# UNITED STATES PATENT AND TRADEMARK OFFICE

APPLICATION NO.	FILING DATE	FIRST NAMED INVENTOR	ATTORNEY DOCKET NO.	CONFIRMATION NO.
10/646,704	08/25/2003	Kenichiro Nakamura	0505-1227P	9815
2292 7590 01/11/2007 BIRCH STEWART KOLASCH & BIRCH PO BOX 747 FALLS CHURCH, VA 22040-0747			EXAMINER PILKINGTON, JAMES	
			ART UNIT	PAPER NUMBER
			3682

**Office Action Summary**

## **DETAILED ACTION**

Figure taken from Riley '824 Figure 3

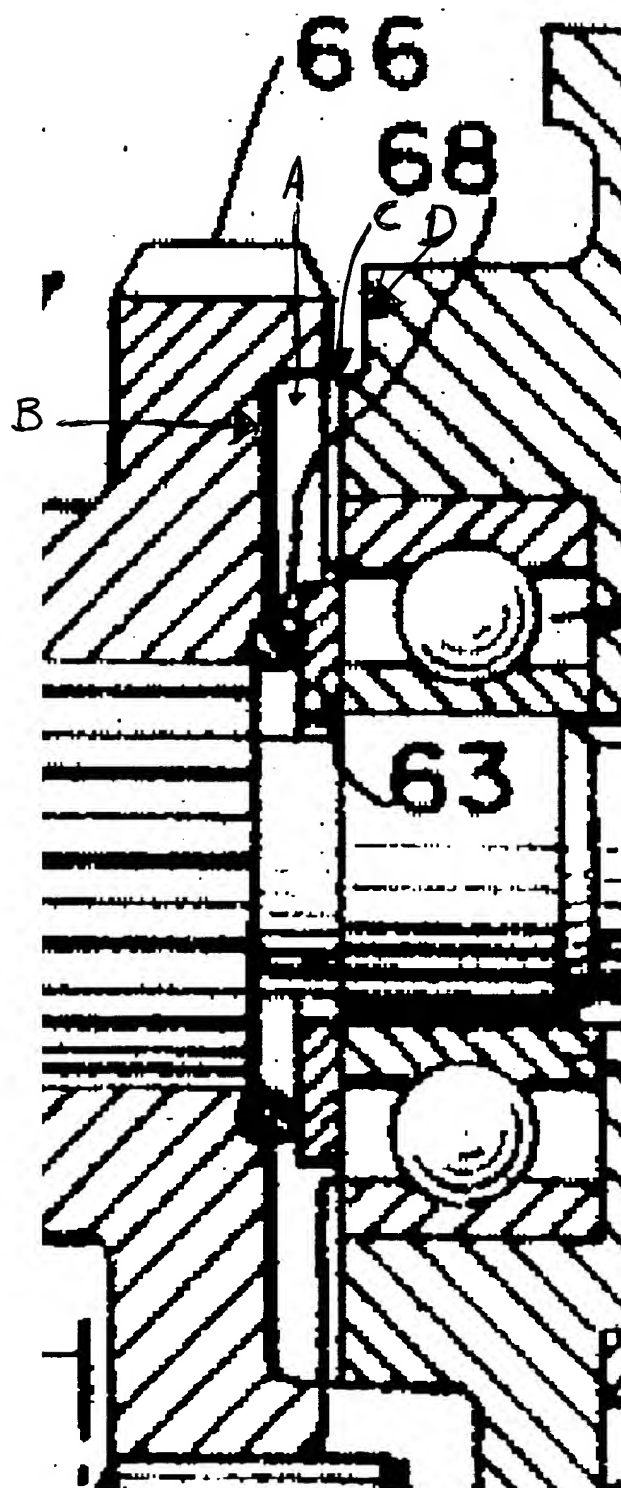
Re clms 4-7, Riley discloses a cylindrical portion (A, see Figure on following page) being formed on a first opposed end face (B) of the first gear (66) and a planar surface (C) on an end face (D) of the second fixed wall (51), wherein said elastic member (68) is surrounded by said planar surface (C) and said cylindrical portion (A); and said cylindrical portion (A) is capable of operative contact with said planar end surface (C) of said second end wall (51) and regulating a bending amount of said elastic member to a predetermined amount.

Re clms 8, 10, 12, and 14, Riley discloses that the elastic member (68) is a rubber washer (an O-ring is a rubber washer).

Re clm 16, Riley discloses a plane washer (63, also regulating device see specification objection above) disposed in a position opposite to said cylindrical portion (A) for surrounding said elastic member (68).
